Board Attachment 1

Excelaron Board Issues/Questions (5/15/12) to Staff

Conditional Use Permit (Excelaron DRC2009-00002)

Figure 1 Applicant Proposed Pad 2 Layout

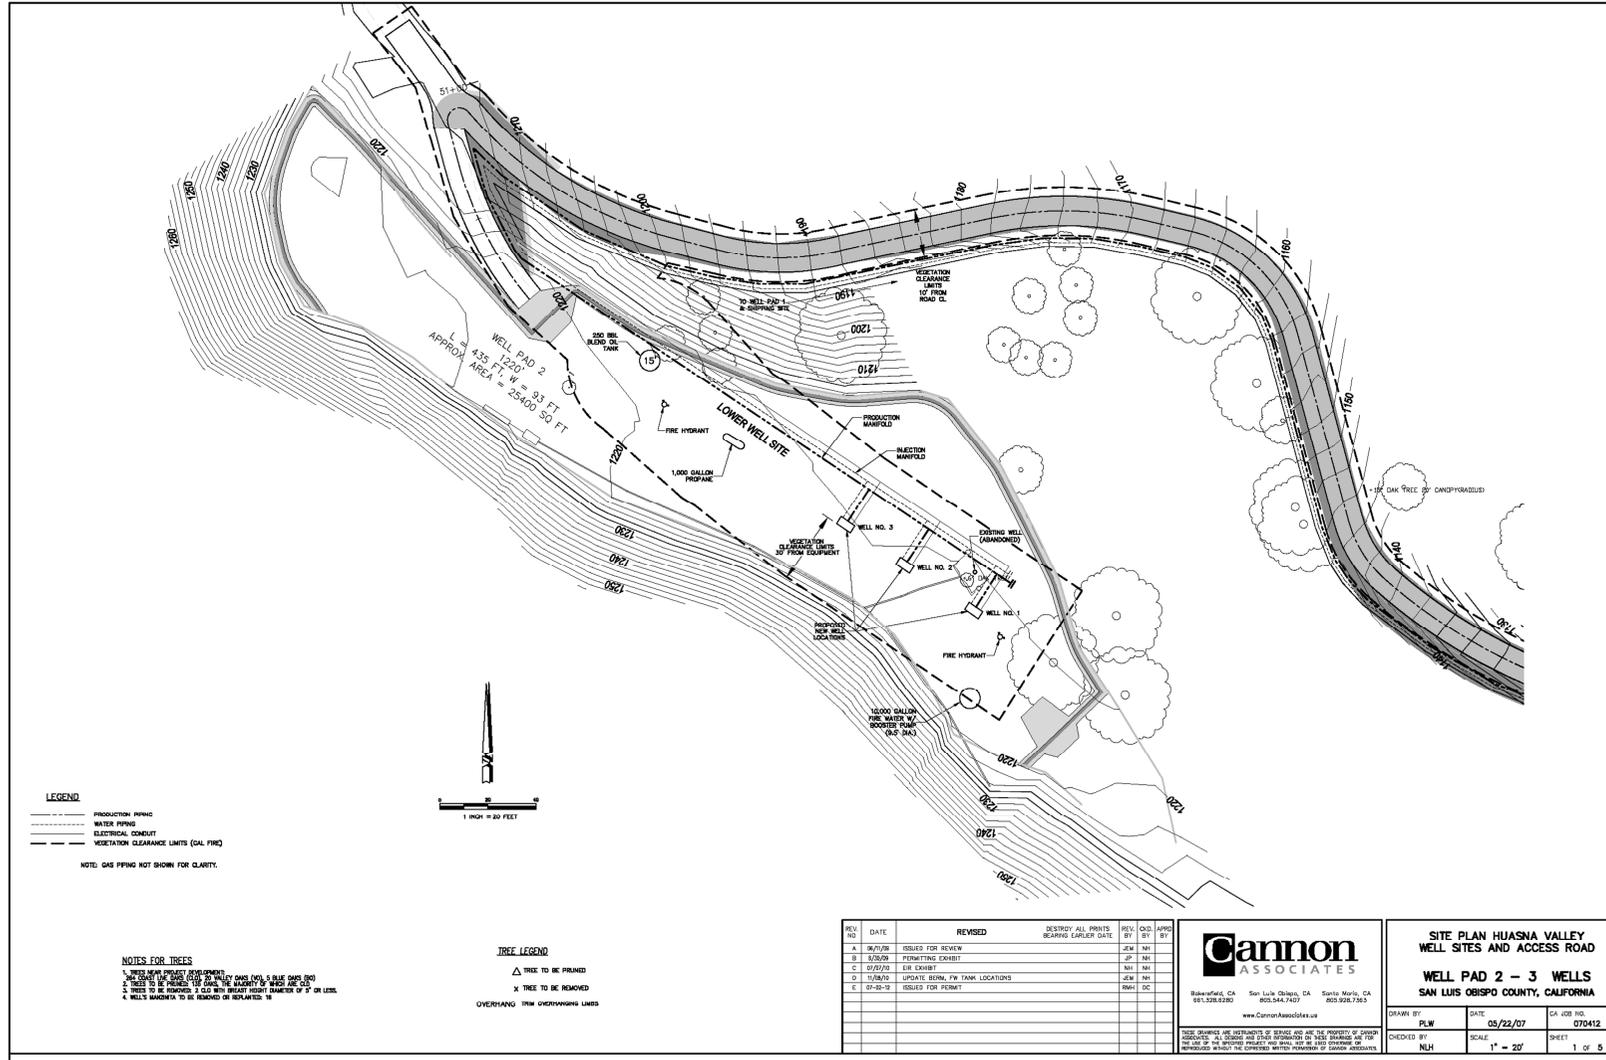
Board Question: *As the Applicant now proposes a revised project with reduced impacts, will this need to be an Alternative under CEQA detailing where they drill and don't drill and where they position wells?*

To address noise and visual impacts associated with Pad 2, the Applicant proposes the following:

- Limit the number of wells at Pad 2 to one (1) during the Exploration and Testing Phase.
- Limit the total number of wells at Pad 2 to three (3).
- Limit the well drilling hours at Pad 2 to between 7 am and 9 pm on week days, and 8 am to 5 pm on weekends.
- Relocate the wells on Pad 2 to the southeast portion of the Pad.

Figure 1 shows the revised layout for Pad 2 based upon the Applicant's proposed alternative. The remainder of this response provides an analysis of the how the Applicant's proposed alternative would affect various environmental impacts identified in the Final EIR.

The FEIR found that the grading of Pad 2 (including the 30-foot clearance and 100-foot fuel modification zone required by CalFire) and the presence of equipment and the drill rig was a significant (Class I) impact. With the Applicant proposed alternative, the equipment and wells would be moved to the southeast portion of Pad 2. However, the footprint of Pad 2 would

Since the size of Pad 2 has not changed the visual impacts associated with the grading, the 30-foot clearance and the 100-foot fuel modification zone would remain significant (Class I). By moving the equipment to the southeast portion of Pad 2, most of the equipment would not be visible. During drilling, the top of the drill rig would still be visible. This would still be considered a significant impact (Class I).

Figure 2 Total Number of Rig Days per Year

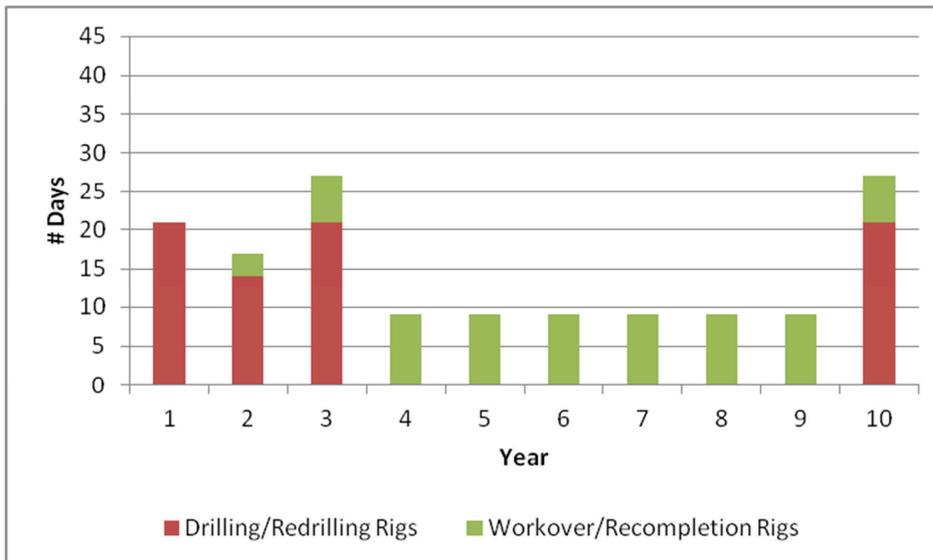
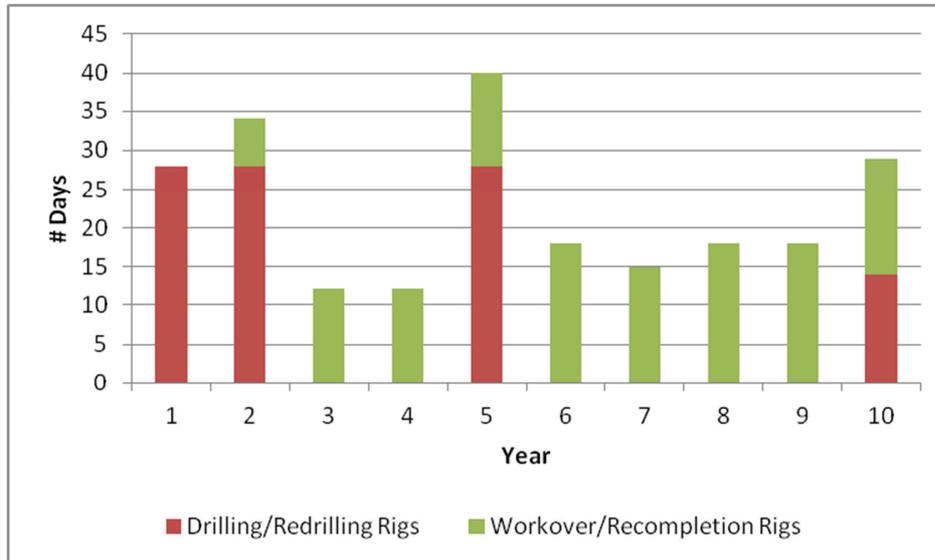
The Applicant has proposed to limit the number of wells at Pad 2 to three (3), and to not drill during the hours of 9 pm to 7 am (and between 5 pm and 8 am for weekends). These changes may serve to reduce the amount of time a drill rig would be present at Pad 2 if the previous maximum of eight wells were considered. Figure 2 provides an update on the days that a drill rig and workover rig would be present at Pad 2 based upon the Applicant's proposed alternative.

1. FEIR assumed a drill rig was present for 14 days per well and that a total of six wells were drilled at Pad 2.
2. Applicant's proposed alternative would have a drill rig present for 21 days per well due to no nighttime drilling, and a total of three wells at Pad 2.
